# LINCOLN PARK STADIUM IMPROVEMENTS

## STOCKER STADIUM

RFI No.	Subject	Posted
1	Vertical Reinforcing Bar Placement at Vertical Cores	6/14/2011
2	Locations of Floor Sinks	6/24/2011
3	Construction Base Elevation 100' 0"	6/14/2011
4	Pile Wall Thickness	6/14/2011
5	Anchor Bolt and Base Plate Finish	6/24/2011
6	Bulletin #1 Plumbing Clarifications	No Post
7	Chase Space for Water Closet Carriers	No Post
8	Elevator Shaft Opening Dimension	7/18/2011
9	Deletion of Area Drains at Dugouts	No Post
10	Trench Drains at Dugouts	7/20/2011
11	Location of Dugout Pump Controls	7/18/2011
12	Surge Pump Connection to Storm Drains	7/18/2011
13	3rd Base Dugout Location	7/19/2011
14	Confirmation of Hot Dipped Galvanized Finish for Anchor Bolts	7/20/2011
15	Height of Press Box Work Surfaces	7/20/2011
16	Added File at West Shear Wall Foundation	7/21/2011
17	Waterproofing at the Dugouts	7/20/2011
18	Location of Floor Sink at Catering Kitchen 105 Walk-In Freezer	No Post
19	Thickness of Piles Along Grid Line 1.2	7/26/2011

100% CONSTRUCTION DOCUMENTS

2 CONCOURSE LEVEL ROOF PLAN  
1/8" = 1'-0"

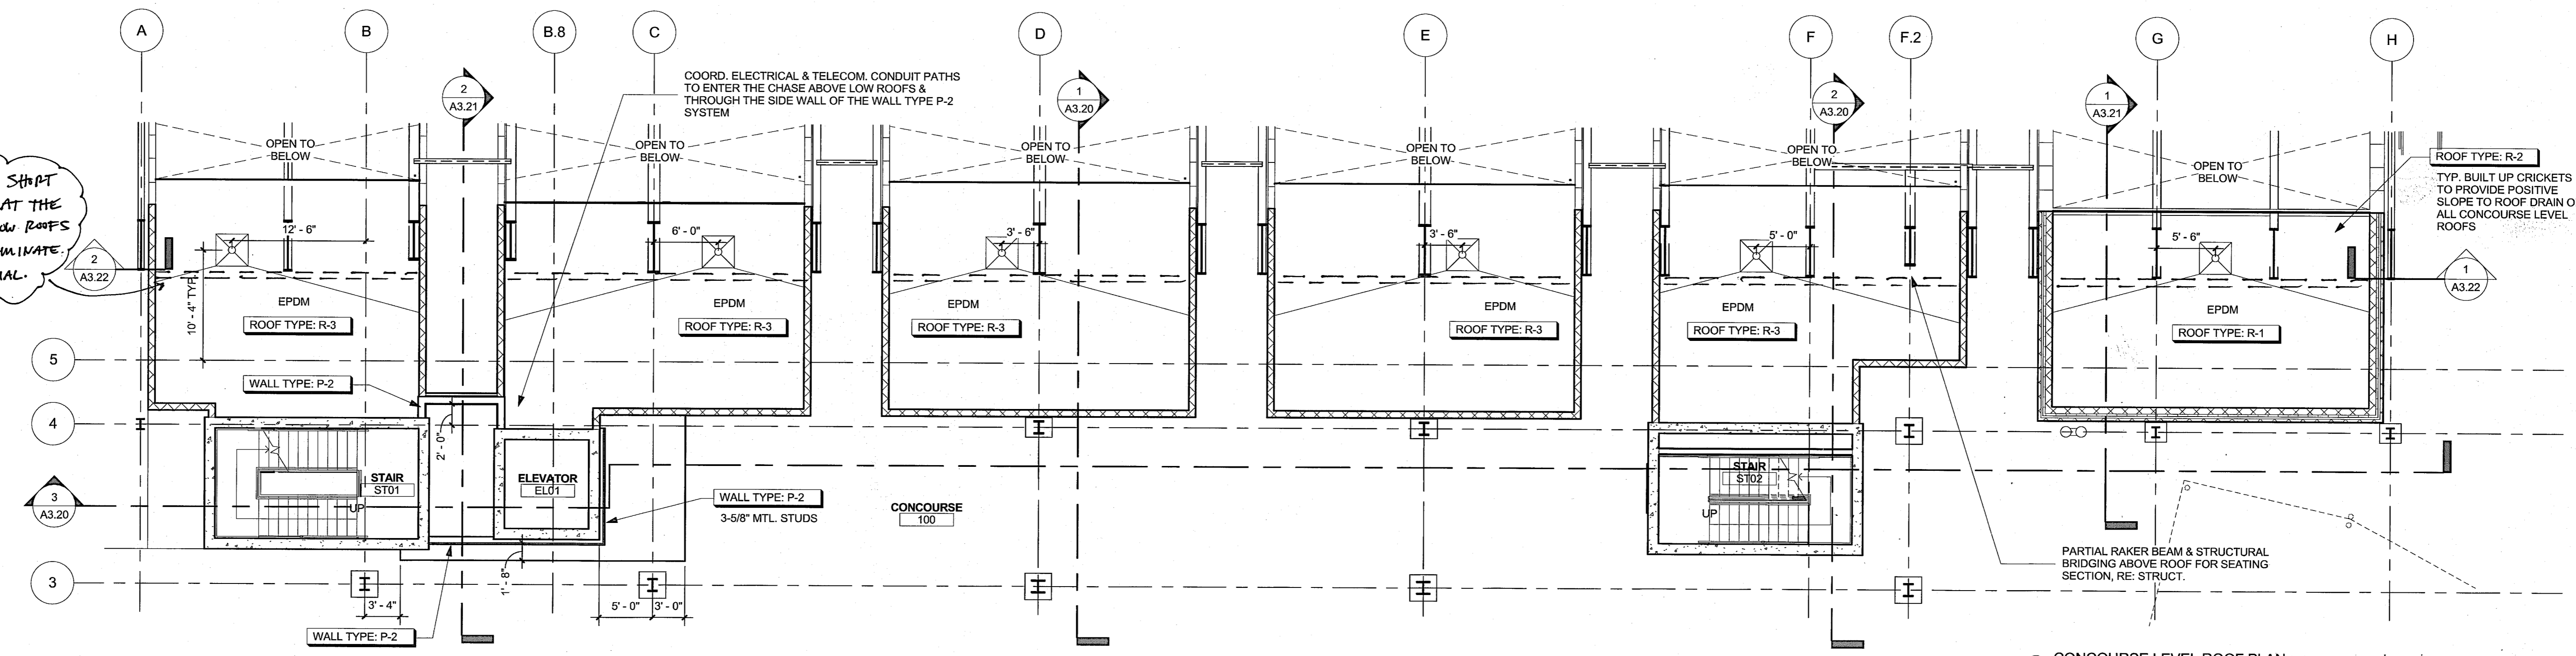
PER RFI-070, SHIRT WALLS ADDED AT THE TOP OF THE LOW ROOFS TO BETTER TERMINATE ROOFING MATERIAL.

1 CONCOURSE LEVEL PLAN  
1/8" = 1'-0"

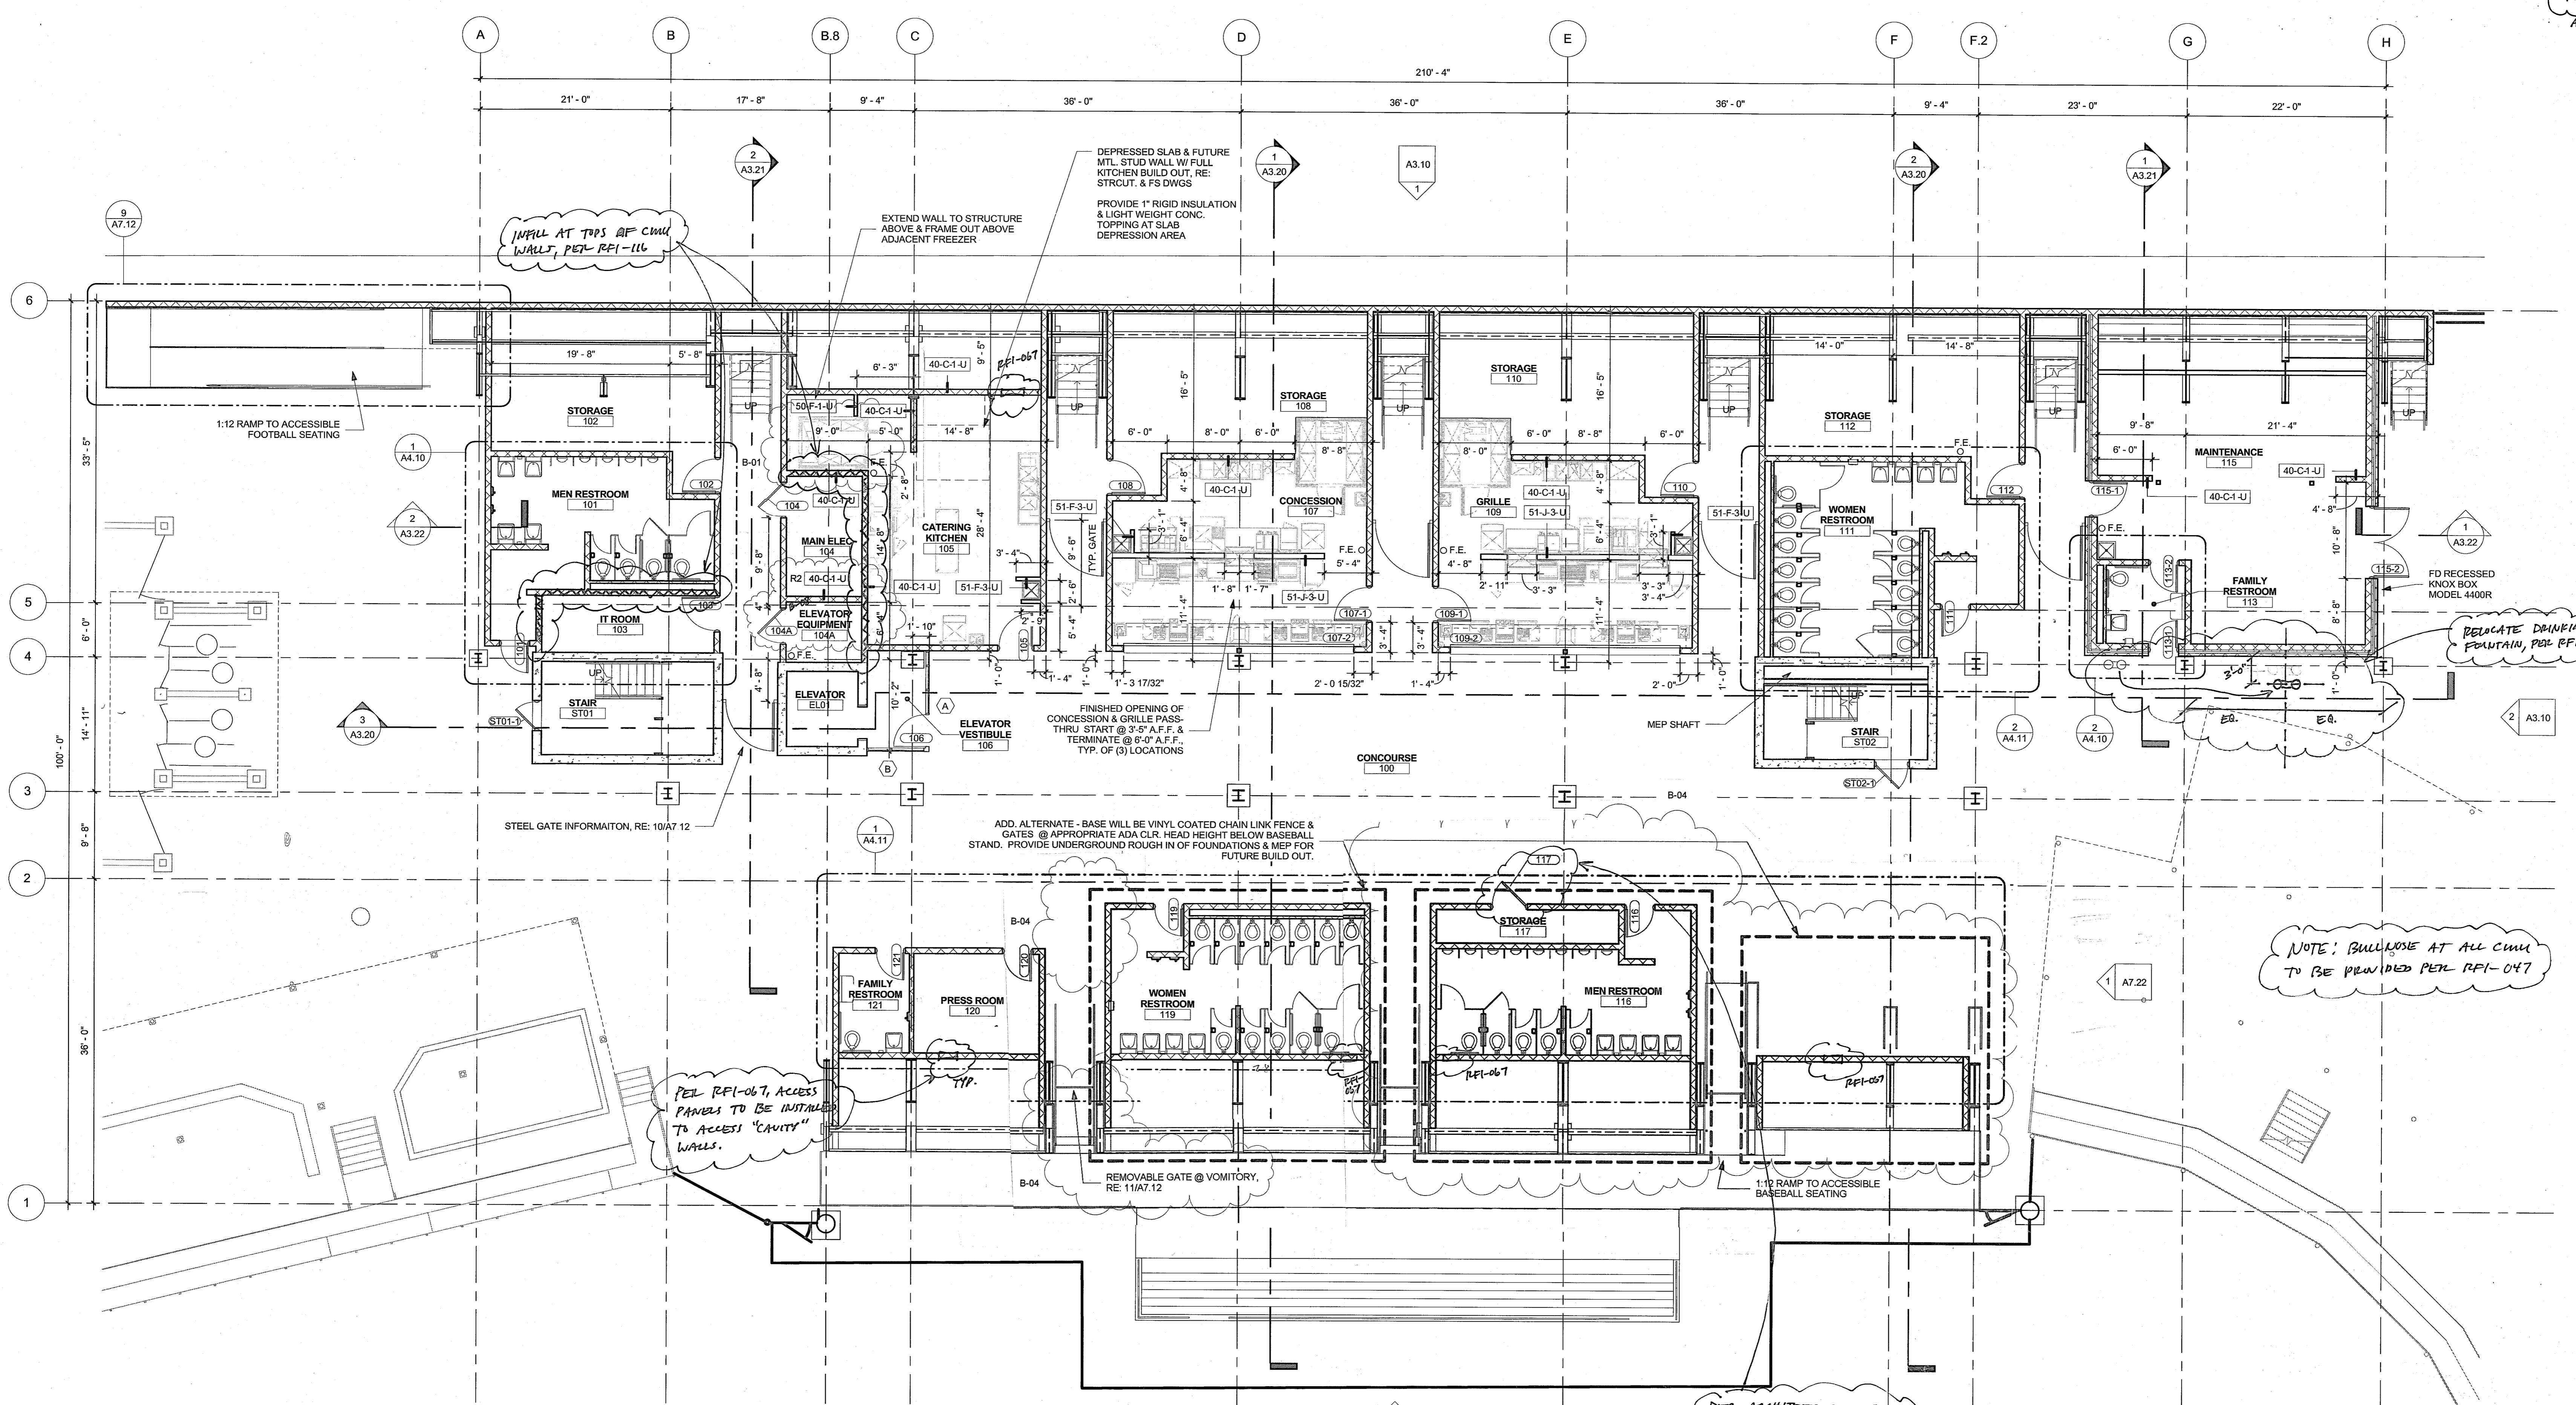
INFILL AT TOPS OF CMU WALLS, PER RFI-116

RELOCATE DRINKING FOUNTAIN, PER RFI-079.

PER RFI-067, ACCESS PANELS TO BE INSTALLED TO ACCESS "CAVITY" WALLS.

NOTE: BUILDOUT AT ALL CMU TO BE PROVIDED PER RFI-047

PER ARCHITECT COMMENT TO SUBMITTAL FILE # 0072, DOOR 117 TO STAIRS AS CLOSE TO 180° AS POSSIBLE. INSTALL FRAME TO ALLOW THIS RANGE OF SWING.
